Project No. Staff Recommendation	Public Hearing: Subarea 10 Amendment Approve
APPLICANT REQUEST	
Plan Amendment	Approve amendment to Subarea 10 Plan.
Detailed Neighborhood Design Plans (DNDP)	Adopt DNDP for 8 th South area (Waverly Place and Woodland-in-Waverly neighborhoods)
SUBAREA PLAN	This amendment replaces current policy for a specified area within Subarea 10 with more detailed language tailored for the unique circumstances in these neighborhoods.
DNDP FOR 8 th SOUTH Public Participation	Staff met with over 50 residents, property owners, and business owners in these two neighborhoods during a series of workshops and meetings held from July-September 2002. Staff presented the final plan at the last meeting on 7 October 2002.
Description	The DNDP outlines the uniqueness of each planning neighborhood.
Waverly Place	The Structure Plan identifies Waverly Place as a fairly low-density urban residential neighborhood. The Detailed Land Use Plan places most of the neighborhood under single-family detached residential policy. Smaller areas of single-family attached and detached and mixed housing policies are at the eastern edge of the neighborhood, generally adjacent the mixed-use and

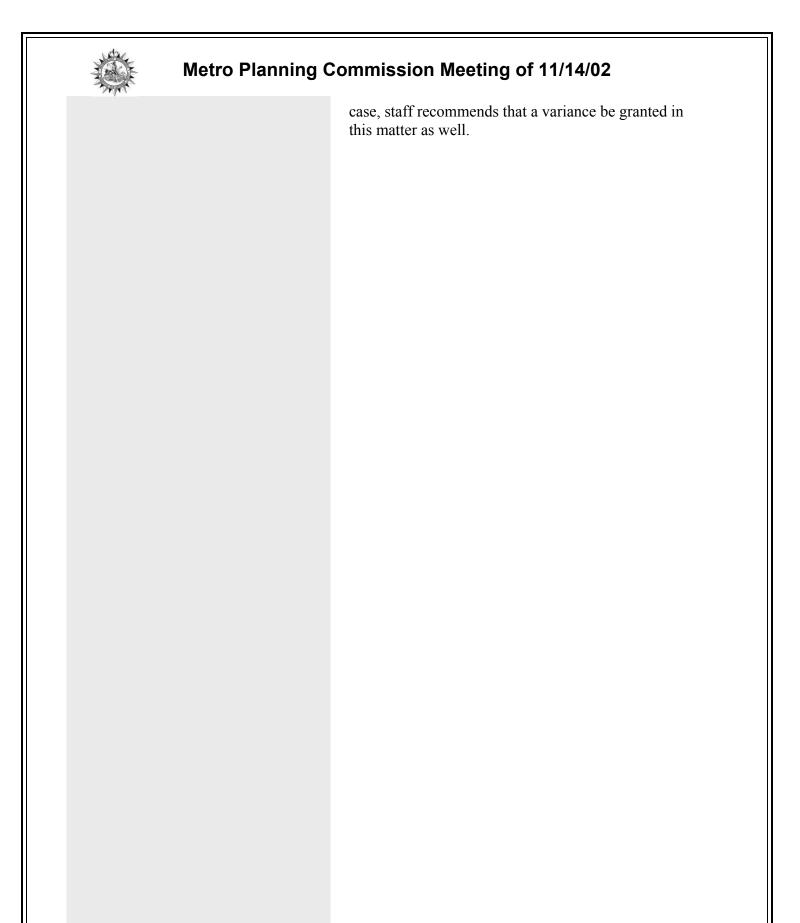
Sidewalk Construction	In order to construct sidewalks at this location curb and gutter will need to be installed in addition to piped drainage and catch basins. The existing pavement will not need to be widened but curb ramps will need to be provided at either end for handicap accessibility. The existing NES poles should not need to be relocated; however, other utilities may be a factor.
TENNESSEE DEPARTMENT OF TRANSPORTATION COMMENTS	"Generally, the Department is supportive of the installation of sidewalks for urban areas. However, the above location is not in the area that has continuity in the sidewalk. The sidewalk does not appear to be effective; therefore, we do not object the city deleting the requirement of the sidewalk installation."

Pursuant to roadway data and photographs provided by the Metro Public Works Department and pursuant to staff examination of the variance request in light of the Zoning Code variance review standards, staff recommends the granting of a sidewalk variance based upon the following:

Gallatin Pike is designated on the Major Thoroughfare Plan as a U6, or a 7-lane arterial highway, which requires a minimum right-of-way width of 108 feet. Currently, Gallatin Pike has a varied right-of-way that is approximately 150 feet in width; however, there is only 60 feet of pavement with a total of five lanes. The U6 designation calls for six travel lanes with one center turn lane and a total roadway width of 88 feet. The applicant would be required to install sidewalks, in accordance with the current Metro Public Works design standard, at the current edge of roadway. Since the thoroughfare plan calls for the addition of one travel lane per side, these newly installed sidewalks would be removed when the road is widened to its designated width. On the other hand, should the applicant install sidewalks at the future roadway edge, the location of those sidewalks would be a "peculiar and exceptional practical difficulty", as stated in Sec. 17.40.370 of the Metro Zoning Code.
